Millstone Nuclear Power Station Unit 3
Request for Additional Information to Support
Proposed Revision to Technical Specification
Table 3.3-1 (PTSCR 3-6-96)

Millstone Nuclear Power Station Unit 3
Request for Additional Information to Support
Proposed Revision to Technical Specification
Table 3.3-1 (PTSCR 3-6-96)

Change in Core Reactivity as Temperature is Raised Isothermally from 68 to 557 °F at Several Points in Life

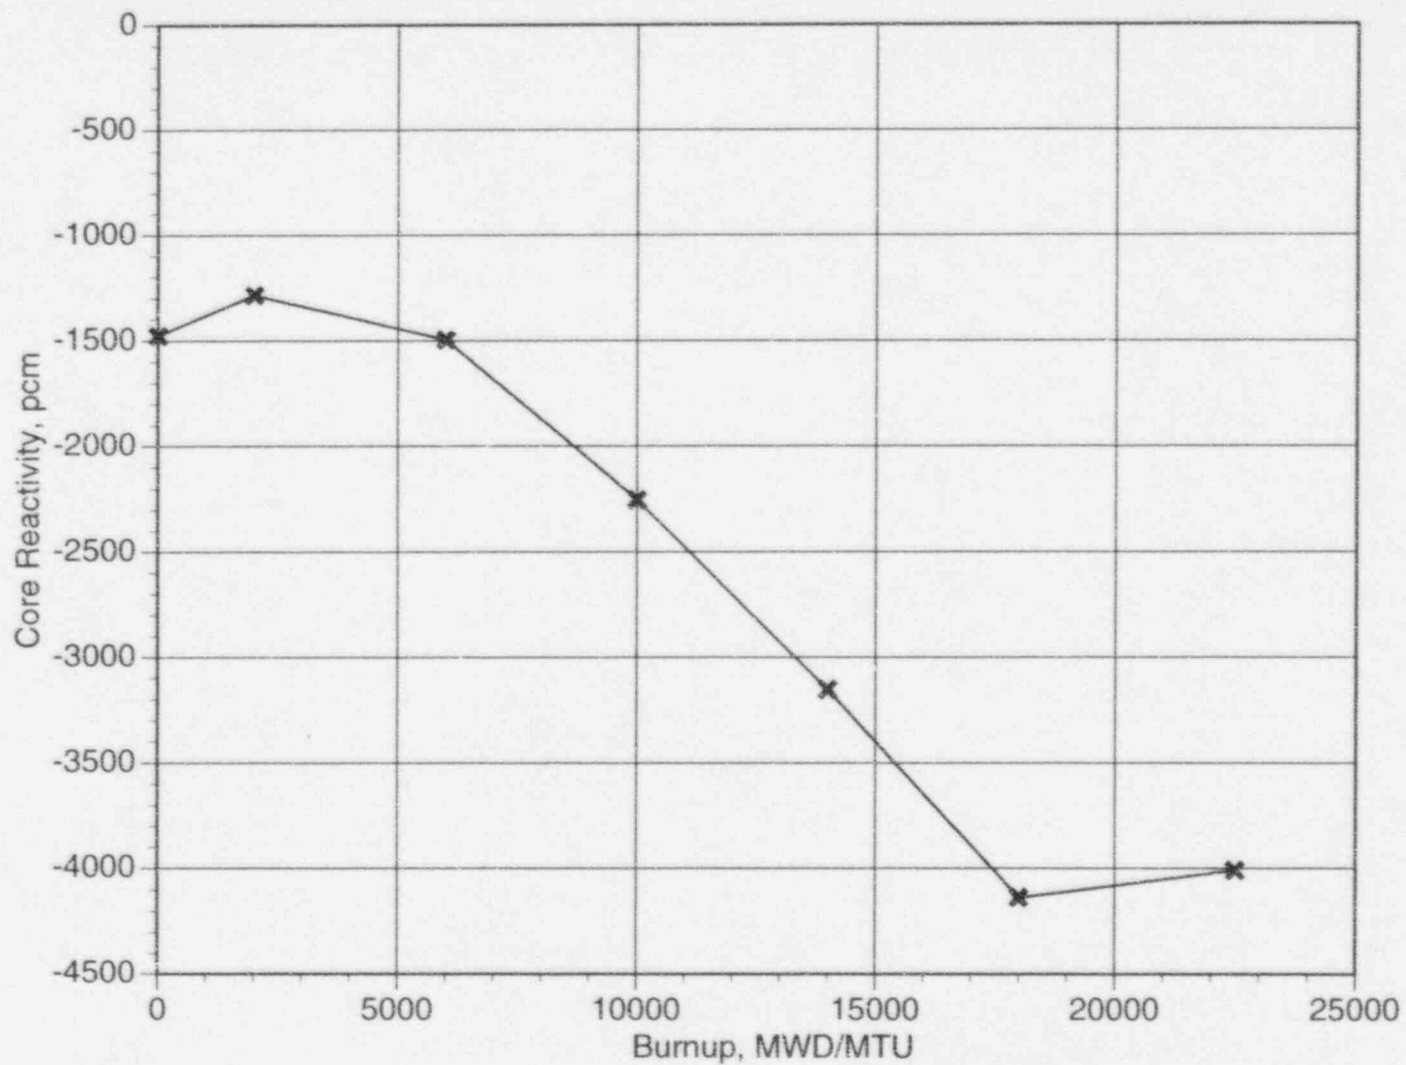
What is the Isothermal Temperature Coefficient for Millstone Unit 3?

The Isothermal Temperature Coefficient (ITC) for Millstone 3 is negative in the temperature range from cold shutdown (68 degrees F) to no load hot (557 degrees F) temperature conditions in a critical rodded configuration. The ITC is the sum of both the moderator temperature coefficient and the fuel Doppler temperature coefficient. For operating conditions where the core is uniformly heated or cooled the associated reactivity change is due to the combined or isothermal effect of both the change in fuel temperature and the moderator temperature. Over reactor core life the ITC becomes more negative with core age primarily due to the reduction in Reactor Coolant System (RCS) boron. The net reactivity change due to a heatup from 68 degrees F to 557 degrees F varies from a low of approximately -1300 pcm at beginning of core life to a high of approximately -4100 pcm at the end of core life. The attached figures illustrate the net change in reactivity of the core on a plant heatup over core life, and the change in reactivity during a heatup for the Millstone 3 plant near its present burnup. The data used to prepare the two figures is contained on the table.

Example: At 0 MWD/MTU core burnup between 68 degrees F and 557 degrees F the reactor must be diluted 238 ppm to maintain a just critical condition with a ARI N-1 rodded configuration while heating up. By multiplying the differential boron worth of -6.2 pcm/ppm times the change in boron the total negative reactivity addition of -1476 is calculated as the reactor is heated up from 68 degrees F to 557 degrees F.
